**Service Information Letter**

<b>Title: Software Upgrade digital ASI and ALTI</b>		
<b>AG-SIL-2018-01-B-EN</b>		<b>Compliance Category:</b>
<b>Applicability</b>		<b>A – MANDATORY B – RECOMMENDED C – OPTIONAL</b>
<b>Aircraft type &amp; model: Any AutoGyro type, fitted with digital ASI (Software Version 2.16 and older) and ALTI (Software Version 2.12 and older)</b>	<b>Betroffene Werknummern: Any AutoGyro type, fitted with digital ASI (Software Version 2.16 and older) and ALTI (Software Version 2.12 and older)</b>	
The maintenance manual to be referenced is this stated or subsequent issue.		As per AutoGyro website
This form is the response from AutoGyro GmbH either against a problem found in the product in service requiring a containment or rectification action, or as service information for aircraft modification incorporation. For help, contact AutoGyro on 49(0)5121 88056-00, or email <a href="mailto:airworthiness@auto-gyro.com">airworthiness@auto-gyro.com</a> .

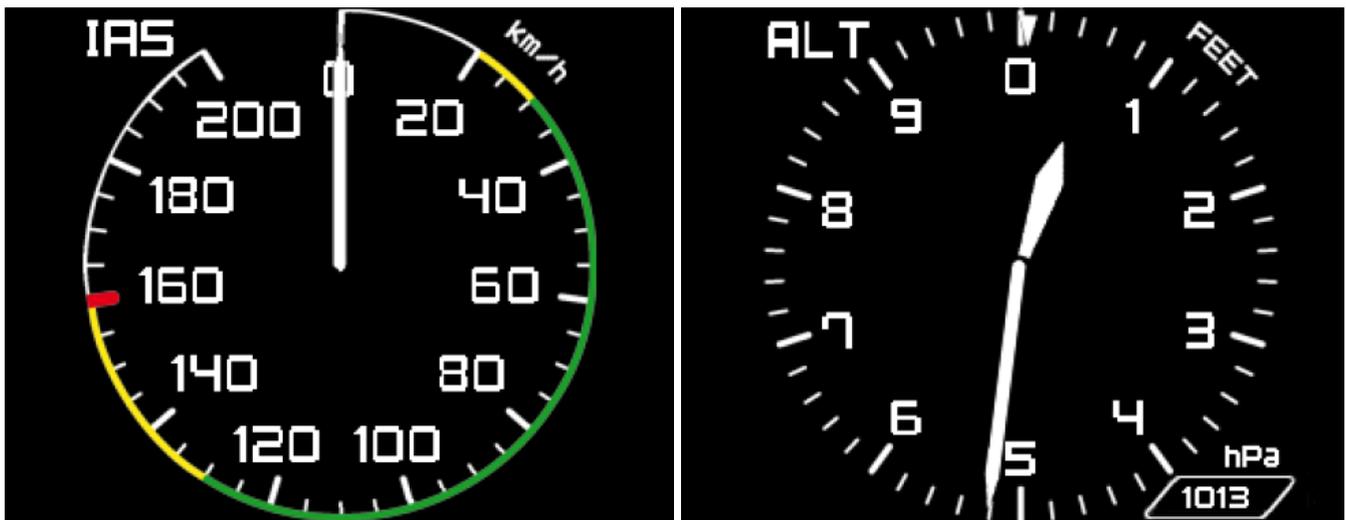
AutoGyro has listened to market feedback regarding the visual appearance of instrument displays, and of the device reliability. The company decided to offer an upgrade to owners that makes the devices easier to read in different lighting conditions, and improves the operational reliability. Any device with a display as shown below may be upgraded to software level 2.17.

**Original instrument display**

**New instrument display**
